Re: Certification Submittal for Final Building Certificate of Occupancy for  
Downtown Parking Structure, [K-14 / D75]  
214 Second Street SW  
Engineer's Stamp Dated 05/17/04

**Re: Downtown Parking Structure Grading and Drainage Plan**  
**Engineer's Stamp dated 9-15-00 (K14/D75)**

**Re: Downtown Parking Structure Grading and Drainage Plan**  
**Engineer's Stamp dated 8-11-00 (K14/D75)**

Downtown Parking Structure  
Grading and Drainage Plan  
(K-14)

Unit Hydrograph for Basin Pro2

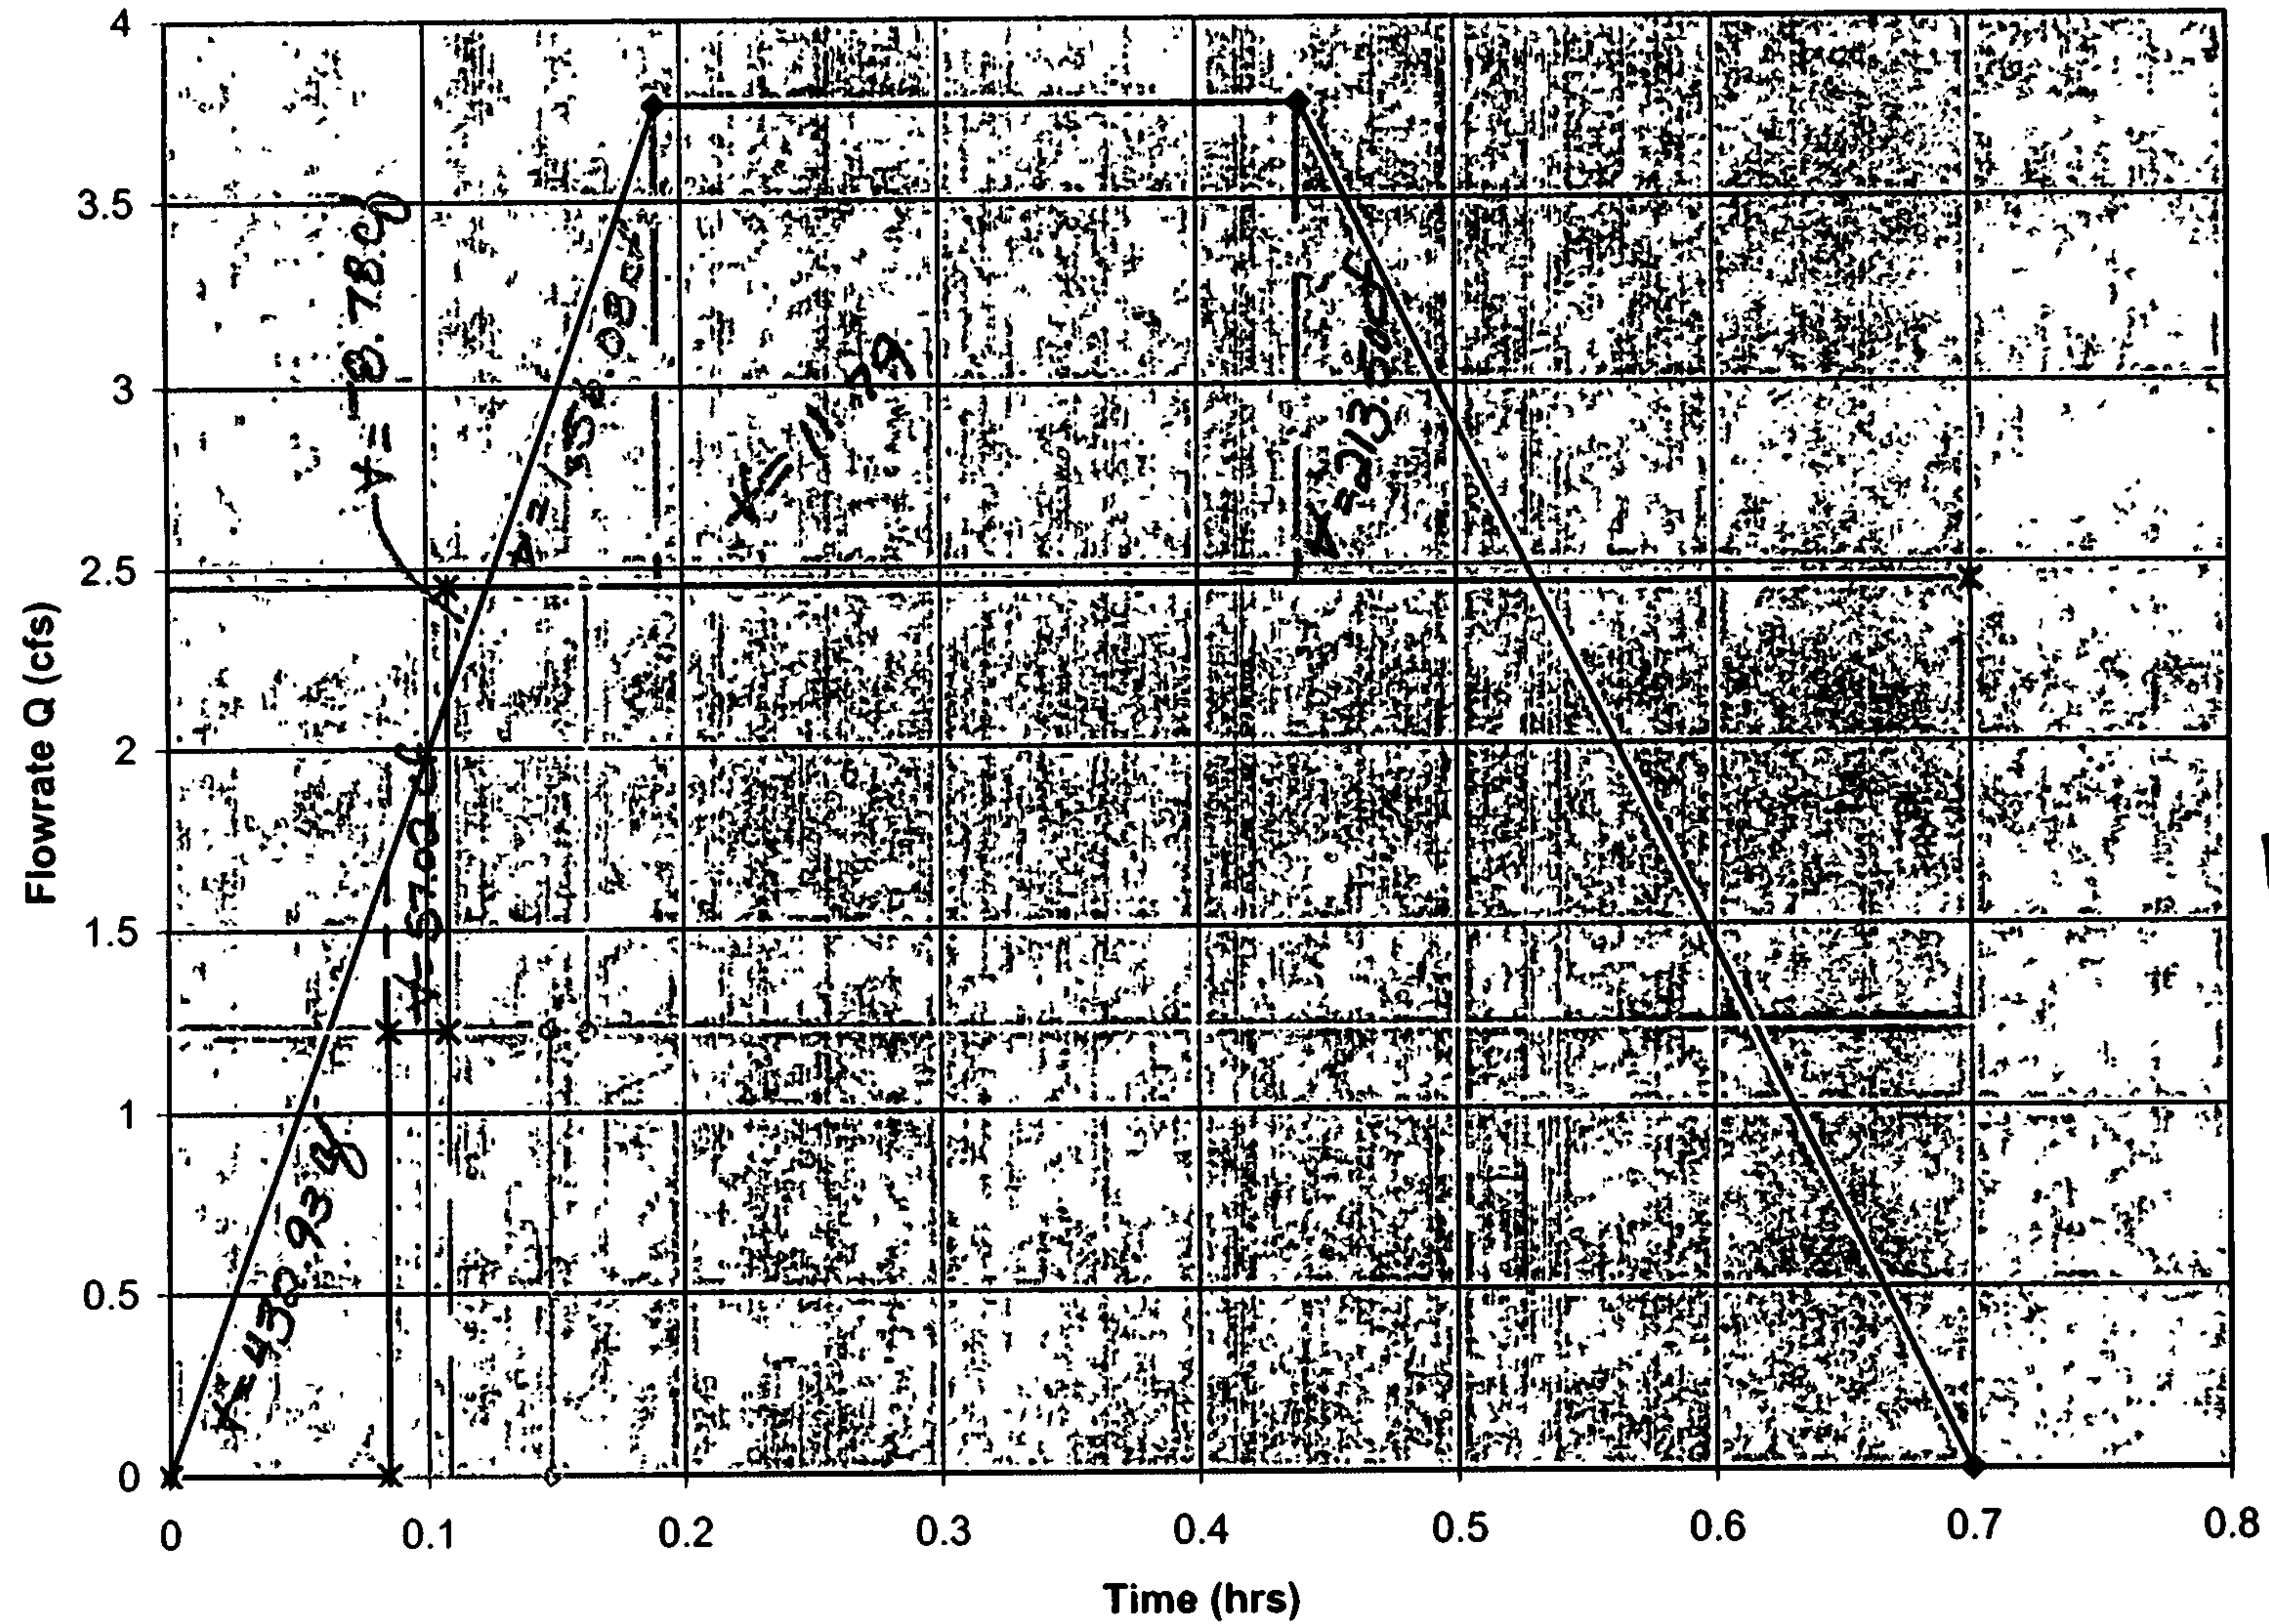
- The report states that 2.22 cfs will be pumped thru the 8" force main. The calculations show 3.76 cfs and the pump hydrograph is drawn at approximately 2.45 cfs. Please clear this up for me. Also, please indicate the velocity in the force main. The 90-degree fitting on the outfall pipe will require blocking – please show or note on plan. Also, it should have some slope to the manhole in order to drain once the pump stops.
- Please provide grate elevations of the inlet at Gold and First in order to determine if there is adequate slope to drain. There is a high point at the PT of return C13 that will create a birdbath.
- Is there offsite runoff entering what was Silver from the south. If so, please provide basin and runoff amount.
- What panel of the flood plain map is your site in?
- Your calculations will need to include developed runoff in basin PRO1.
